Safety Alert 171228

Addition of Safety Cables to Existing Parachute Retention Lines

NOTICE ID: SA171228

1.2 SUBJECT: Mandatory addition of 2 additional safety cables to existing TL-2000 parachute retention line system.

**LEFT SIDE VIEW
(RIGHT SIDE SIMILAR)**

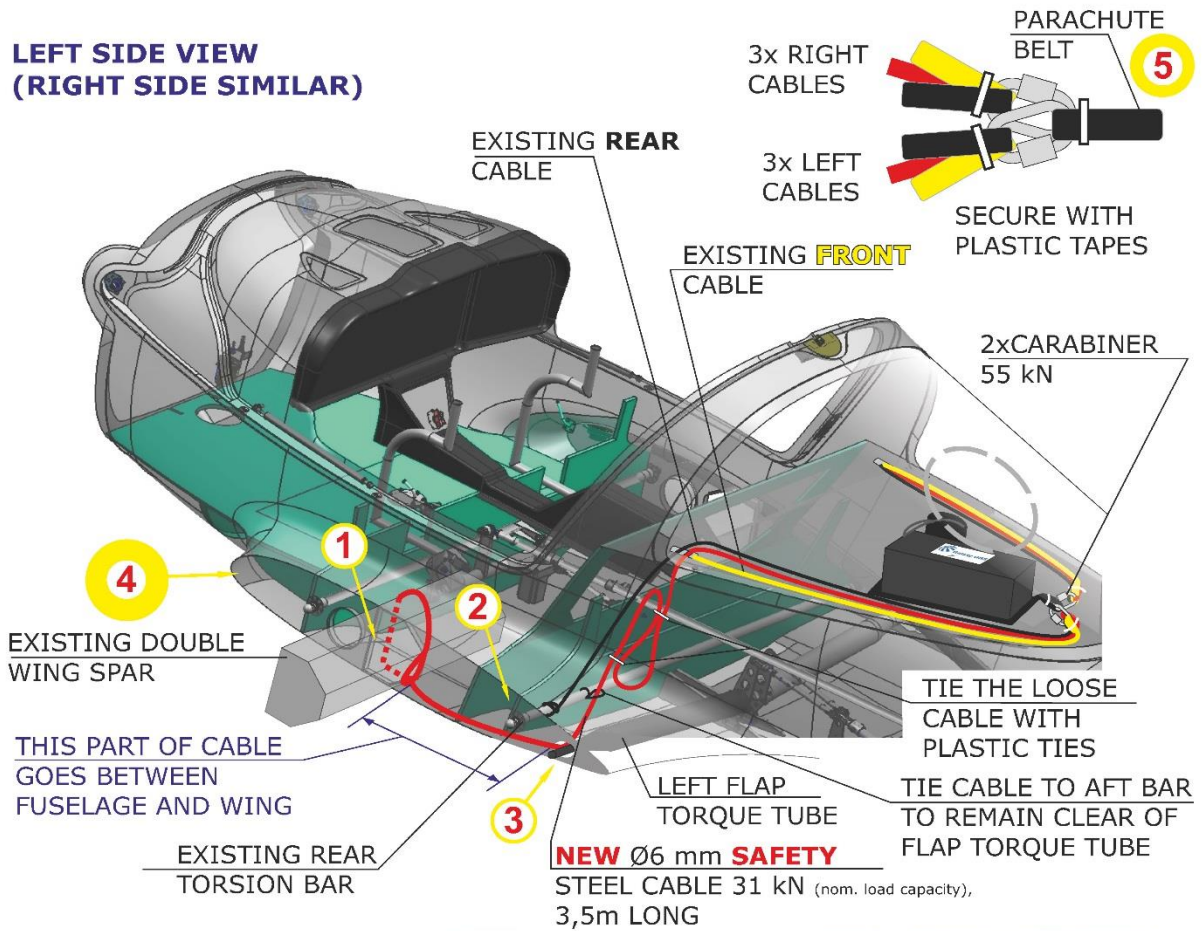
5. Push the large loop end on the of safety cable forward under both spars, then up and aft. See the drawing for orientation assistance.
 6. Pass the small loop end of the cable through the large loop end so that the cable aims aft and low and captures both spars in a large 'lasso'. Secure the created lasso loop around the spars with plastic ties. See figure 1 on the attached drawing

7. Extend the remaining end of the cable out of the lower (under the seats) cabin area then aft of the second spar and to the outside of the fuselage. Remove any slack and secure it in place with plastic ties. See the attached drawing, figure 1.

8. Extend the cable further aft and **UNDER** the aft torsion ball. See the attached drawing, figure 2.
 9. Extend the cable to reenter the fuselage at the forward opening of the flap torque tube. See the attached drawing, figure 3.

11. Back inside the aft fuselage, take up the cable slack from the wing and secure the cable to the aft torsion bar inside the fuselage. Tie the cable in two locations to prevent any interference with the movement of controls, wires, lines or the flap torque tube. (The existing aft chute cables are also attached to the outboard ends of this torsion bar.) See the attached drawing for details.

16. Close the carabiner threads which will now have 7 loops attached. Use a bit of medium strength thread locker on the threads.
17. If there is not sufficient room on the single carabiner, an additional may be ordered from SportairUSA. See the attached drawing figure 5 to distribute the cables to the main parachute belt. **Do not install a non-load rated carabiner!**
